Data Request No. 3.01 (Continued):

IIEC Response to Data Request No. 3.01 (Continued):

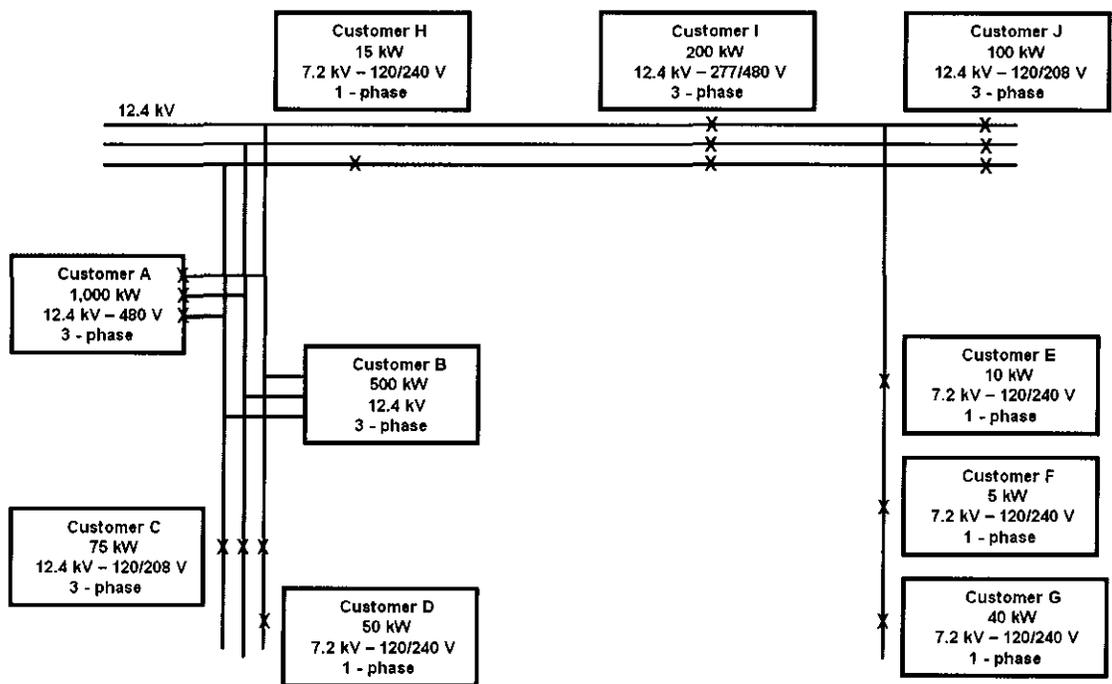
Customer	IIEC Proposes Customer Cost Responsibility for Cost of Black Circuit	IIEC Proposes Customer Cost Responsibility for Cost of Red Circuit	IIEC Proposes Customer Cost Responsibility for Cost of Blue Circuit
A			
B	X	X	
C			
D			
E			
F			
G			
H			
I			
J

Mr. Stowe relies on certain assumptions in responding to this question. These assumptions are:

- 1) Based on information provided in ComEd's question, Mr. Stowe assumes that both Customers A and B are served via an ESS and that, in both cases, the ESS resides on the customer's premises. Therefore, Mr. Stowe assumes that the red lines that run from the red branch circuits to the Customer A & B boxes, enter the customers' premises at the primary voltage shown, 12.4 kV. Therefore, the lines entering the premises of both Customers A and B are at primary voltage (i.e., both Customers A and B are primary customers).
- 2) Consistent with the above, Mr. Stowe assumes that for all other customers, i.e., Customers C through J, the lines entering the customers' premises are at the voltage on the low side of the referenced transformer, represented by the Xs shown. The

transformers represented by the Xs are assumed to be ComEd transformers that perform the transformation indicated by the voltage changes shown for each customer – e.g., for Customer C, ComEd performs a 12.4 kV to 120/208 V transformation before the customer connection shown.

- 3) Mr. Stowe further assumes that the black main line circuit and the red and blue branch circuits, where the voltage transformation occurs for the rest of the customers, do not “enter the customers’ premises” at a primary voltage, since the depiction of the customer connection in those figures differs from what is shown for Customers A and B. Therefore, Mr. Stowe assumes that Customers C through J are secondary customers.
- 4) Finally, Mr. Stowe assumes that the voltage level of a customer is the voltage of the lines entering the customers’ premises, consistent with the way ComEd charges for MKD of customers in the High Voltage Delivery Class and as included in the “exemplar” Primary Voltage Delivery Class rates.

Based on the assumptions stated in ComEd’s question, as well as those stated by Mr. Stowe above, Mr. Stowe answers as follows:

Customer	IIEC Proposes Customer Cost Responsibility for Cost of Black Circuit	IIEC Proposes Customer Cost Responsibility for Cost of Red Circuit	IIEC Proposes Customer Cost Responsibility for Cost of Blue Circuit
A	X	X	
B	X	X	
C	X	X	X
D	X	X	X
E	X	X	X
F	X	X	X
G	X	X	X
H	X	X	X
I	X	X	X
J	X	X	X

Mr. Stowe notes that both primary and secondary customers utilize the black, three-phase, main line circuit and red, three-phase branch circuit, but only secondary customers use the blue, single-phase branch circuit. In addition, at page 40 of its order in Docket No. 08-0532, the Commission directed ComEd to provide function based definitions of service voltages for facilities. Mr. Stowe interpreted this to mean that ComEd should define facilities as “primary” when those facilities function to serve primary and secondary customers, and as “secondary” when those facilities, such as the blue line circuit, function to serve only secondary customers.

Mr. Stowe’s conclusion therefore, with reference to the diagram provided by ComEd as part of this question, is that the costs associated with single-phase primary distribution facilities, such as those illustrated in the diagram by the blue lines, should be allocated only to secondary customers, since those facilities serve only secondary customers. (See Mr. Stowe’s Direct Testimony at 14:321-15:323). Costs associated with three-phase facilities, such as those illustrated in the diagram by the red or black lines, should be allocated to both primary and secondary customers.
